# Construction Traffic Management Plan – Airport Terminal Station

SMWSASSM-PLD-ATL-TF-PLN-000001

Parklife Metro D&C

FIGURE 4: ATL STATION ARCHITECTURAL ELEVATIONS (PRELIMINARY)

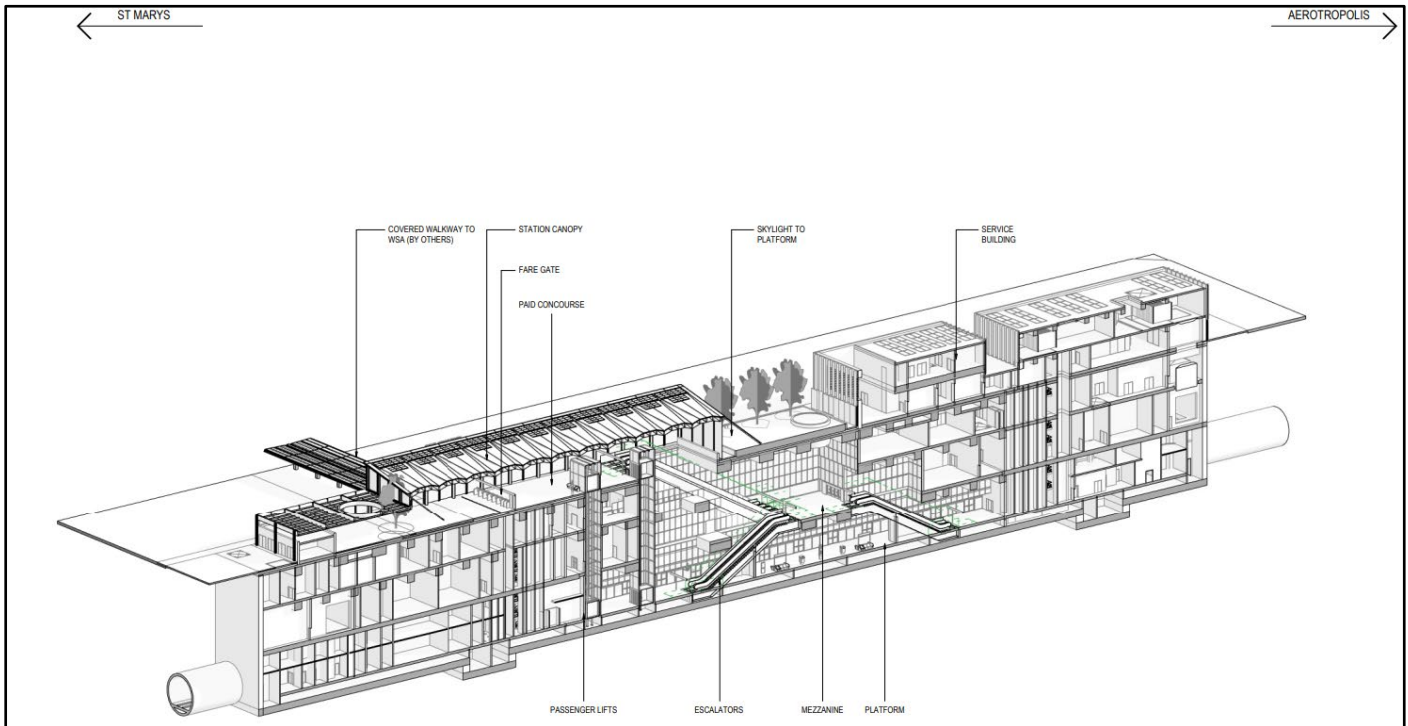
05	9/10/2023	TFN	FLARUE	SMWSASSM-PLD-ATL-TF-PLN-000001	Figure 4	NA	ABP elevatons are shown, this should be changed to ATS	Observation		N
	27/10/2023	PLD	WZHENG	SMWSASSM-PLD-ATL-TF-PLN-000001	Figure 4	NA	The diagram in Figure 4 is the correct elevation for ATL. However, the caption of the diagram is incorrect and this has been updated in the revised CTMP.	Observation		N
06	9/10/2023	TFN	FLARUE	SMWSASSM-PLD-ATL-TF-PLN-000001	Appendix B	NA	There is no Risk Assessment attached	Observation		N
	27/10/2023	PLD	WZHENG	SMWSASSM-PLD-ATL-TF-PLN-000001	Appendix B	NA	We apologise for this error. Please find the updated CTMP with Risk Assessment attached.	Observation		N
07	45211	SMD	LBAKER	SMWSASSM-PLD-ATL-TF-PLN-000001	3.3, 4.1,	Site Access Schedule	At this time, PLM will not receive access to S3 until the 26 Jan 2024. Portion S4 is currently listed as 4 Jan 2025 in the Site Access Schedule.	Observation		N

FIGURE 7: PROJECTED ATL HV NUMBERS

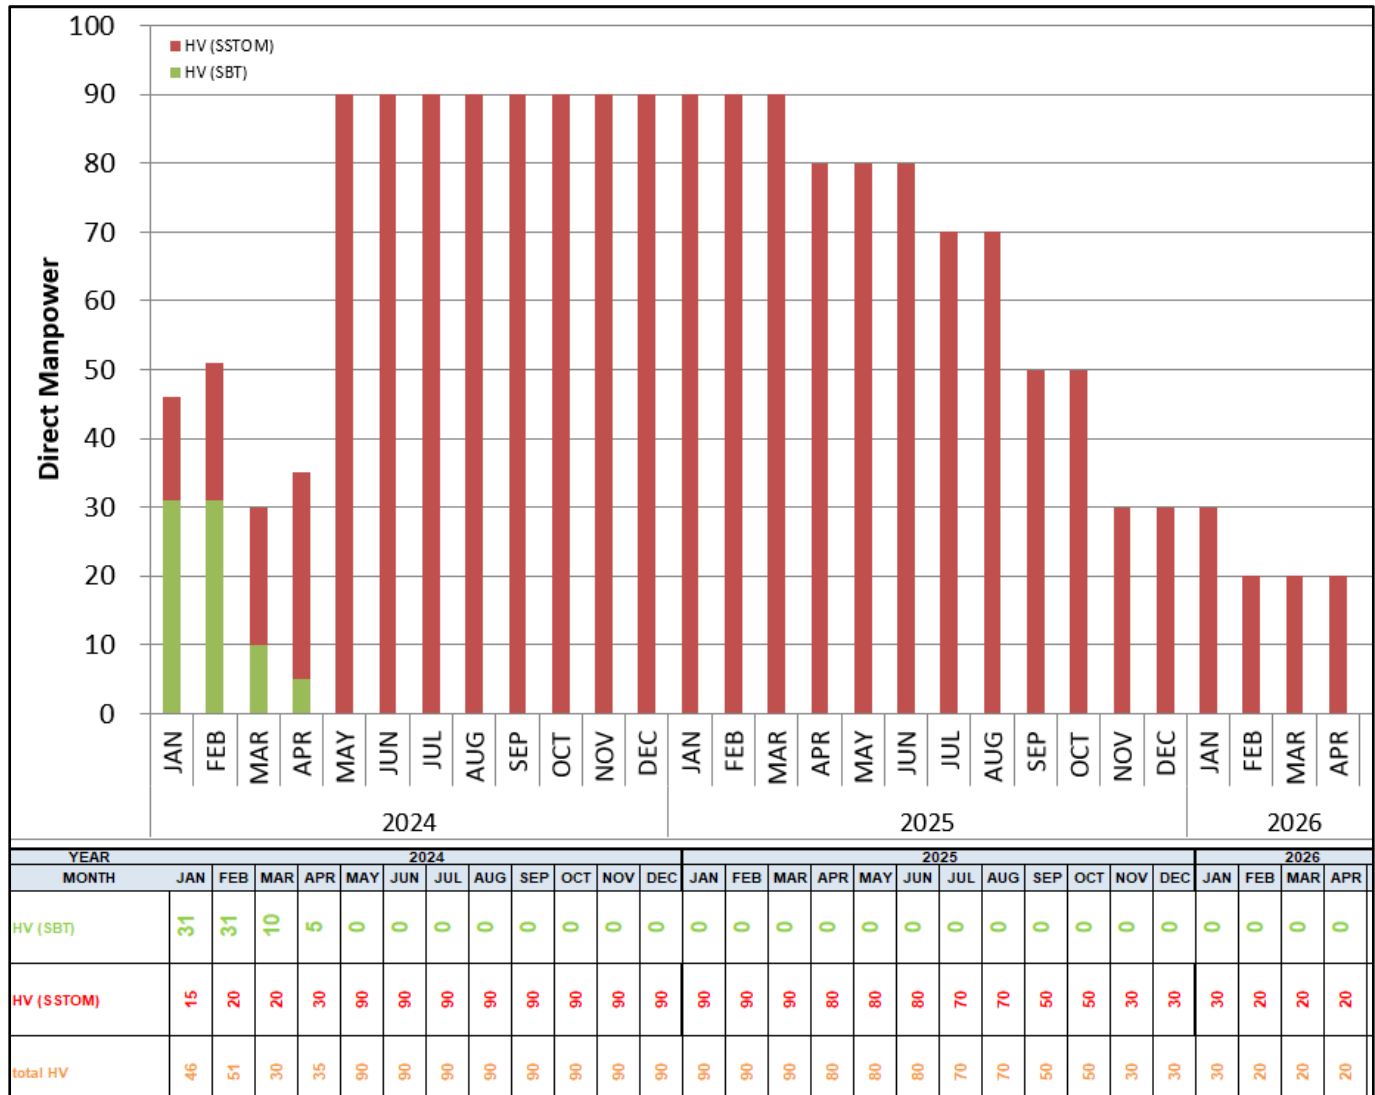
09	12/10/2023	TFN	QMINHLA	SMWSASSM-PLD-LDN-TF-PLN-000001.A.S3.A.01	Section 4.5.1_Fig. 7	N/A	SP - In order to understand overall traffic impact on the network, can you please provide/include expected LV (SSTOM) generation for during all the stages of ATL construction?	Observation		N

NO.	DATE	COMPANY	RAISED BY	REVIEW DOC. NO.*	DOCUMENT REF*	DEED REF*	COMMENTS / RESPONSE	COMMENT CATEGORY*	LINKED ITEM NO	CLOSED OUT
	27/10/2023	PLD	WZHENG	SMWSASSM-PLD-LDN-TF-PLN-000001.A.S3.A.01	Section 4.5.1_Fig. 7	N/A	As outlined in Section 5.1 of the CTMP, the projected LV generation during the peak is in accordance with the EIS Construction Movement allocation.	Observation		N
10	12/10/2023	TFN	QMINHLA	SMWSASSM-PLD-ATL-TF-PLN-000001	Turning paths	N/A	BS - Turnpath for left turning 19m AV turning left from Badgery's Creek Road (BCR) into LAR 06A/6B seems to be tracking in the middle of a dual lane roundabout without straddling prior (on approach to the roundabout) - this is a safety concern due to potential (lack of) horizontal clearances between two vehicles on approach to the roundabout. Additional turnpath required showcasing a design vehicle travelling straight through NB on BCR whilst a 19m AV is turning left into 06A/6B road.	Observation		N
